Access Compliance Report Public Rights-of-Way (Curb Ramps)

Intersection ID: 11877 Main Street: BILLY_GRAHAM_PY Cross Street: N/A Location: NW **Overall Compliance: No** ADA ID: 844F4FFB2219 Ramp Type: Perp Initial Pass/Fail: Fail Severity Score: 36.25

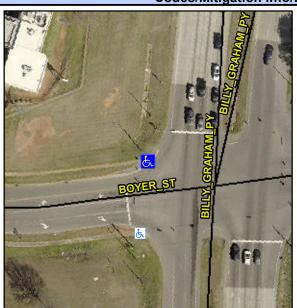
Possible Solutions: Remove & Replace Entire Ramp. Surveyor Notes: N/A PROW/ADA: Not Found, R304.5.1, R304.2.2, R302.7

Field Measurements/Component Compliance					
Compliance Description Data		Data	Comp	liance Description	Data
N/A	Ramp Length (in)	60.0	No	Ramp Slope (%)	10.1
No	Ramp Width (in)	46.0	Yes	Ramp XSlope (%)	0.9
N/A	Flare Type LT	N/A	N/A	Flare Type RT	N/A
N/A	Flare Slope LT (%)	N/A	N/A	Flare Slope RT (%)	N/A
N/A	Flare Traversable LT?	N/A	N/A	Flare Traversable RT?	N/A
N/A	Landing Length (in)	N/A	N/A	DWS Provided?	N/A
N/A	Landing Width (in)	N/A	N/A	DWS Contrast?	N/A
N/A	Landing Slope (%)	N/A	N/A	DWS Length (in)	N/A
N/A	Landing X Slope (%)	N/A	N/A	DWS Full Width?	N/A
N/A	Landing Curb? (Y/N)	N/A	N/A	DWS Offset (in)	N/A
N/A	Shared Landing?	N/A			
N/A	Gutter Ponding?	N/A	N/A	Gutter Slope (%)	N/A
N/A	Gutter Lip Ht (in)	N/A	N/A	Gutter X Slope (%)	N/A
N/A	Painted X Walk1?	No	N/A	Painted X Walk2?	N/A
	X Walk 1 Direction	To SW		X Walk 2 Direction	N/A
N/A	X Walk 1 Width (in)	N/A	N/A	X Walk 2 Width (in)	N/A
	X Walk 1 Slope (%)	2.1		X Walk 2 Slope (%)	N/A

X Walk 1 X Slope (%)	1.6		X Walk 2 X Slope (%)	N/A
N/A	Ramp inside XWalk1?	N/A	N/A	Ramp inside XWalk2?	N/A
	Road Slope (%)	N/A	N/A	Clear Space?	N/A
	Road X Slope (%)	N/A	N/A	Clear Space to XWalk (in)	N/A
N/A	Any Obstructions?	N/A	N/A	Storm Grate/Utility Hazard?	N/A
	Obstruction Type			Storm Grate/Utility Type	
		N/A			N/A
			No	Surface Condition? (G/P)	Poor
4
